**FIELD CLARIFICATION**

CIEE  
CUSTOM HOUSE SQUARE  
300 FINE STREET  
PORTLAND, ME

CLASSIFICATION NUMBER: 001  
REVISION:  
INITIATION DATE: 06 JUNE 07  
ARCHITECT'S PRODUCT NO: 26-2045

**SHEET TITLE:**  
NEW CONSTRUCTION-  
4TH FLOOR  
FINISH PLAN

**1 NEW CONSTRUCTION - FINISH PLAN**  
SCALE: 1/8" = 1'-0"

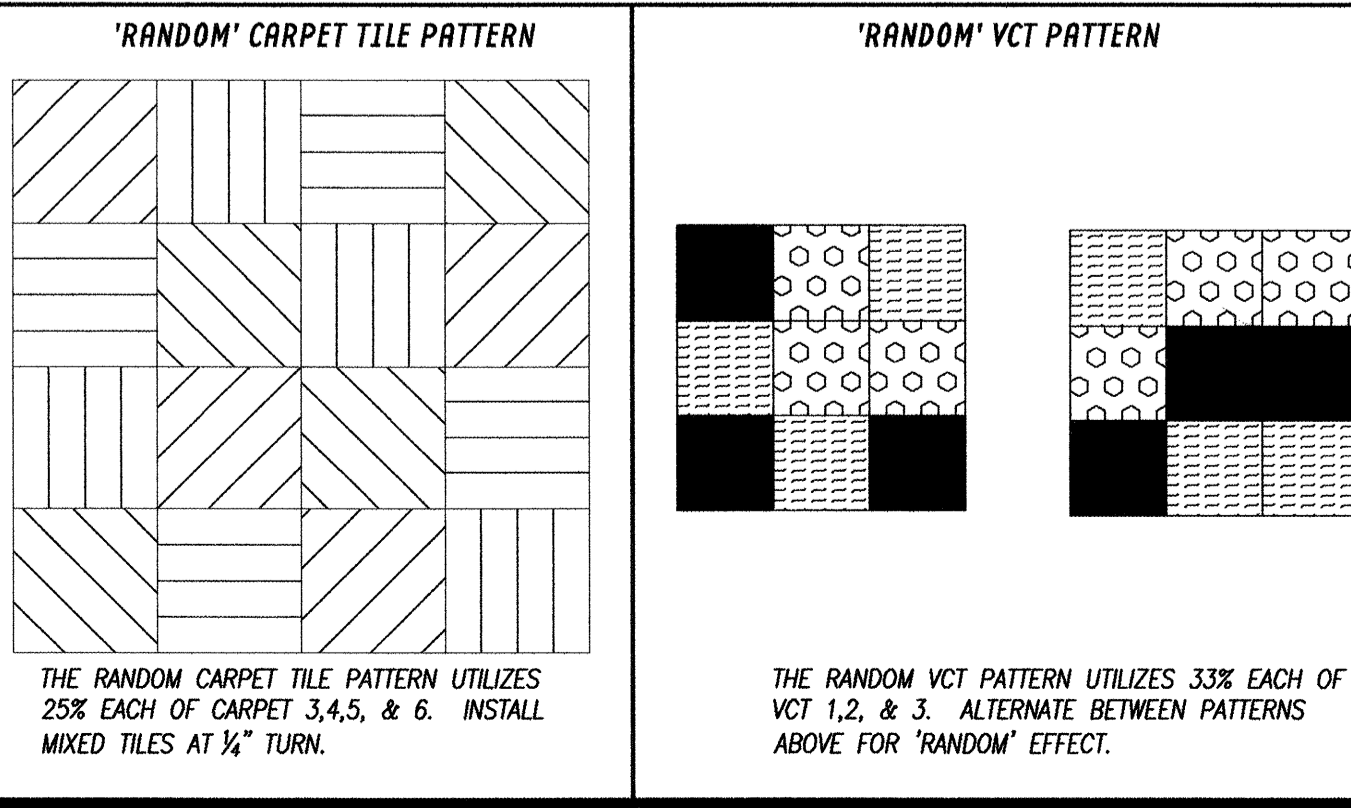
FIELD ISSUES - SHEET NO. 4 GRG. 5 -  
OPEN OFFICE CARPET CALLED OUT TO BE:  
CPT4  
SHAW CONTRACT GROUP  
PATTERN: 59446 CASCO, COLOR: 49305 (CARPET TILE).

CLARIFICATION - SHEET NO. 4 GRG. 6 -  
OPEN OFFICE CARPET SHALL BE:  
CPT1  
SHAW CONTRACT GROUP  
PATTERN: PORTLAND, COLOR: 94201 (BRAND/ROUND)
